ECK 5TH ADDITION

Re: S/D 97-70 One-Step Final Plat Of ECK 5TH ADDITION

STAFF REPORT
(One-Step Final-Approved 9/18/97)

CASE NUMBER: S/D 97-70 ECK 5TH ADDITION

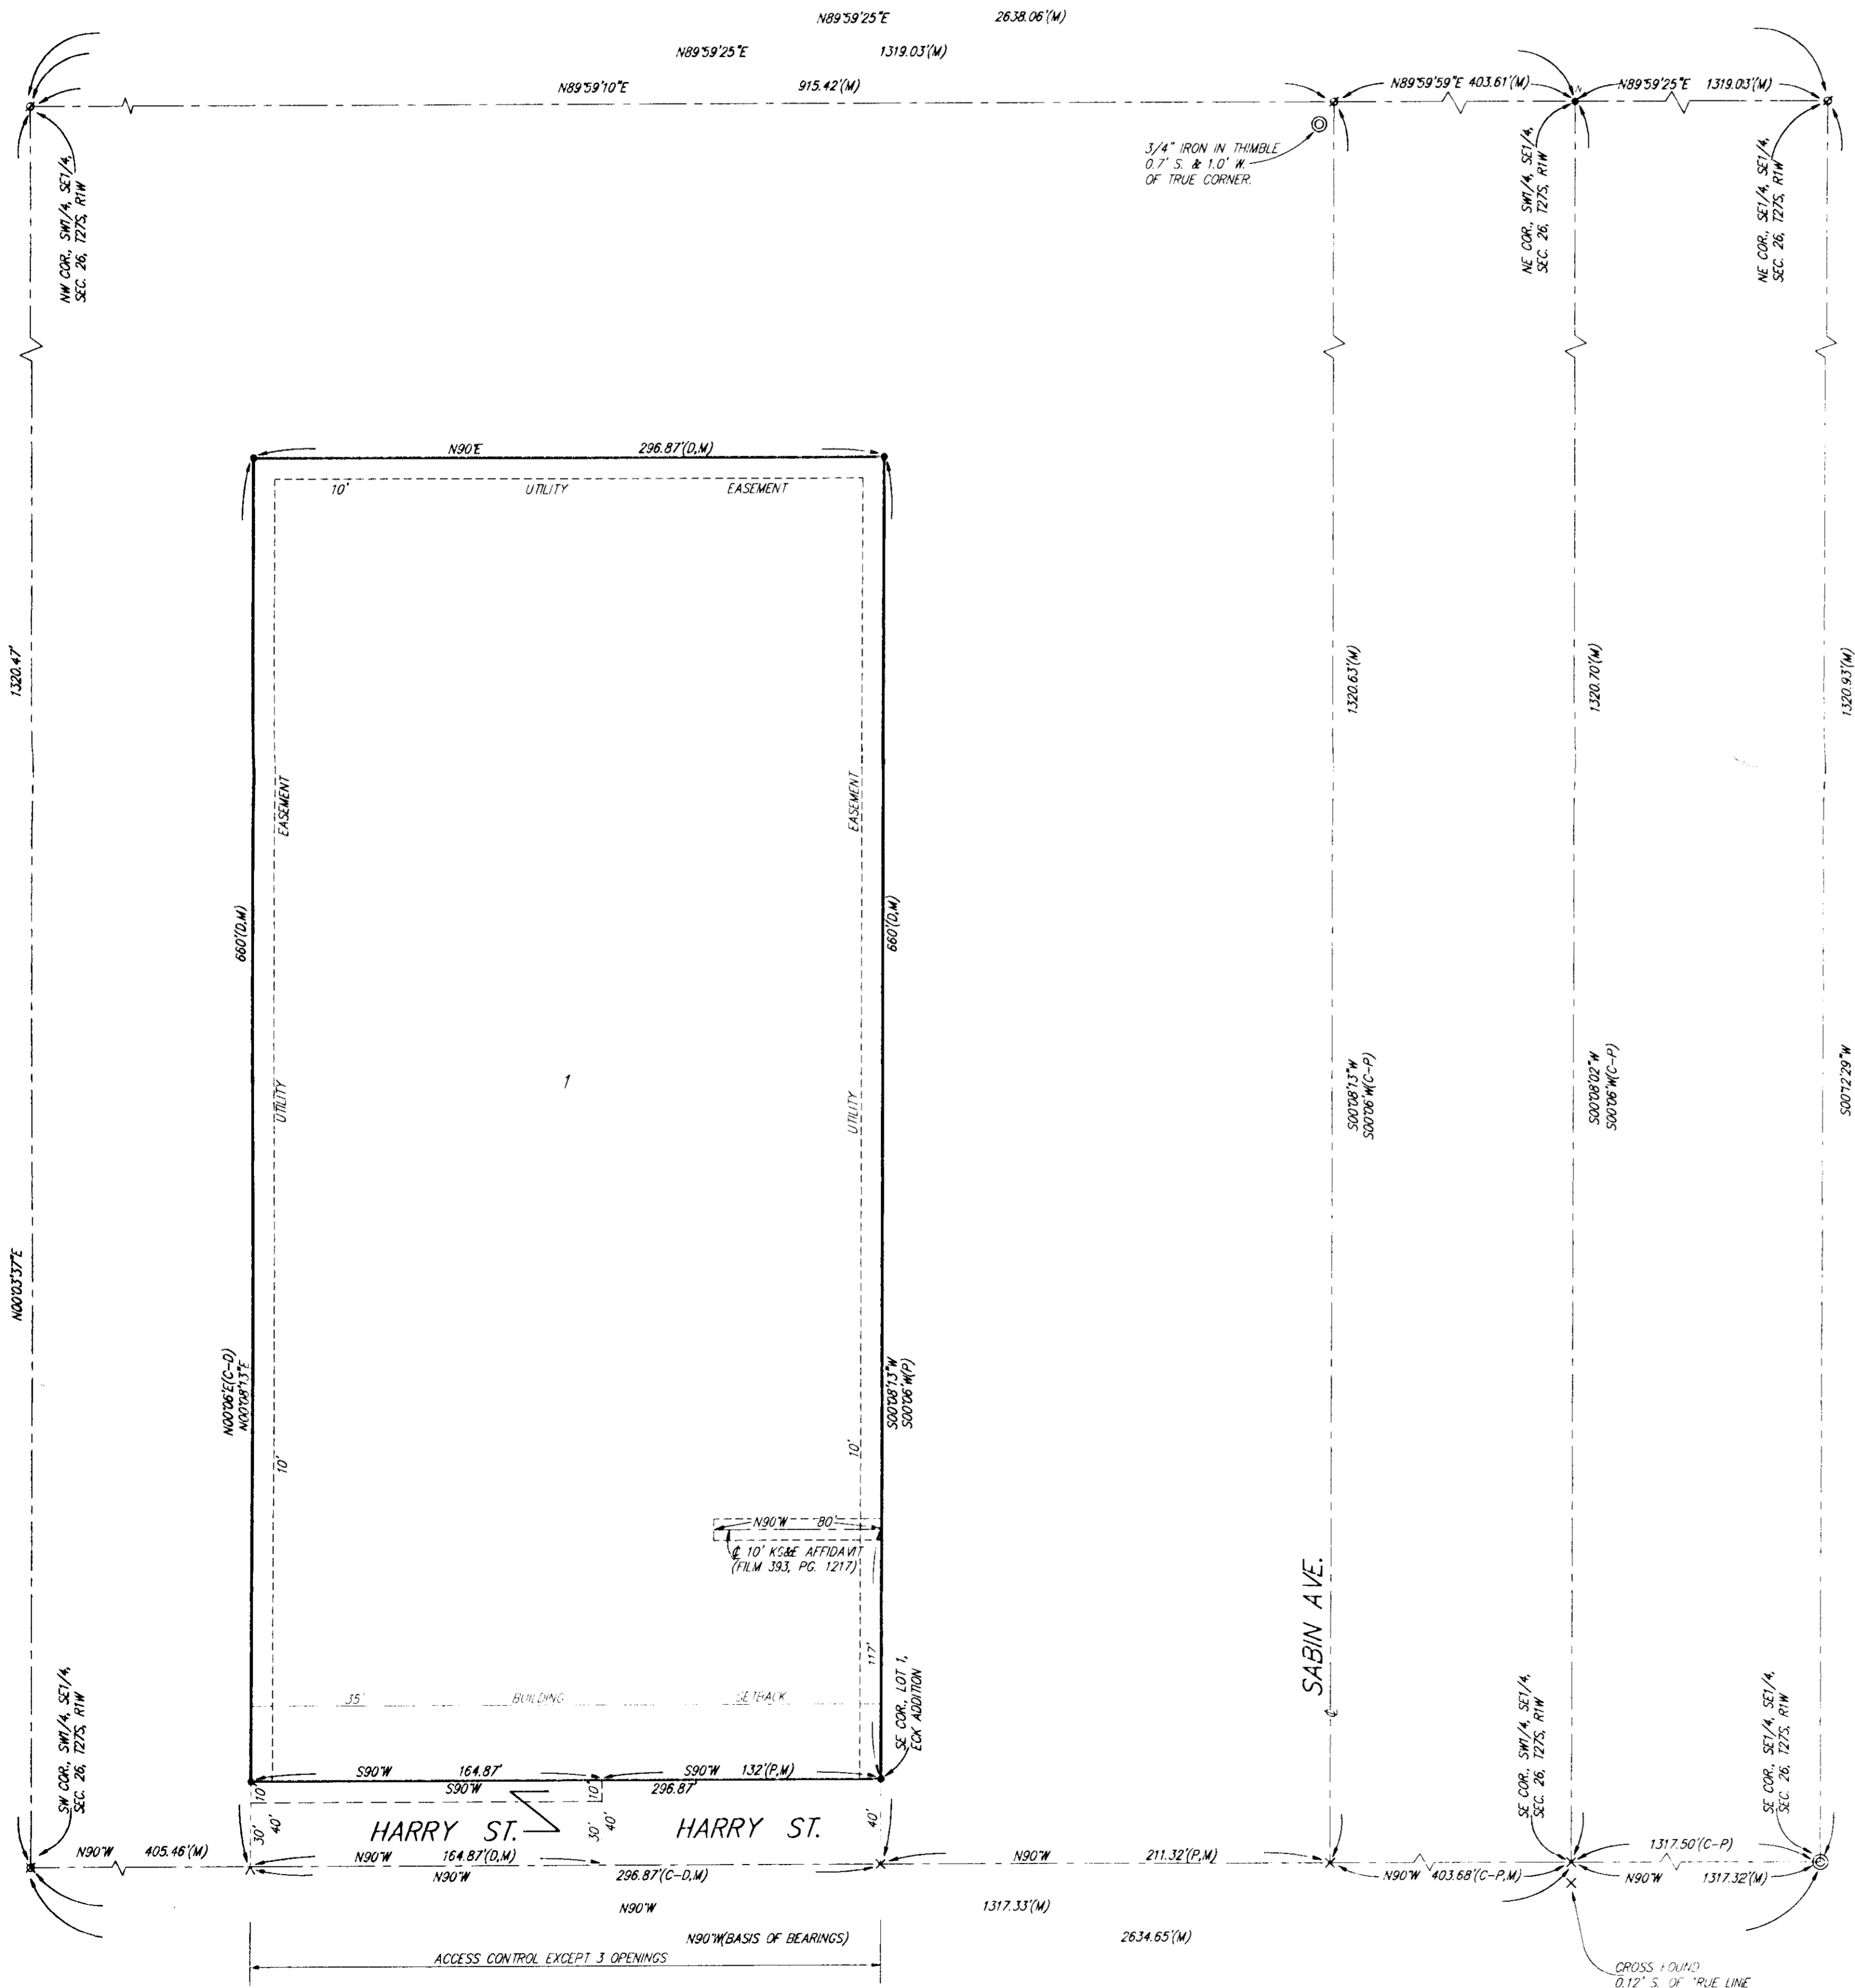
- M. The scale should be corrected on the final tracing. The preliminary plat has a scale of 1 inch equals 50 feet and the final plat has a scale of 1 inch equals 100 feet. Both drawings are the same size but have different scales are shown on the plat.

- N. The distances from the tie point to the point of beginning do not correlate with those in the plat's text. Before the final tracing is submitted this should be corrected.
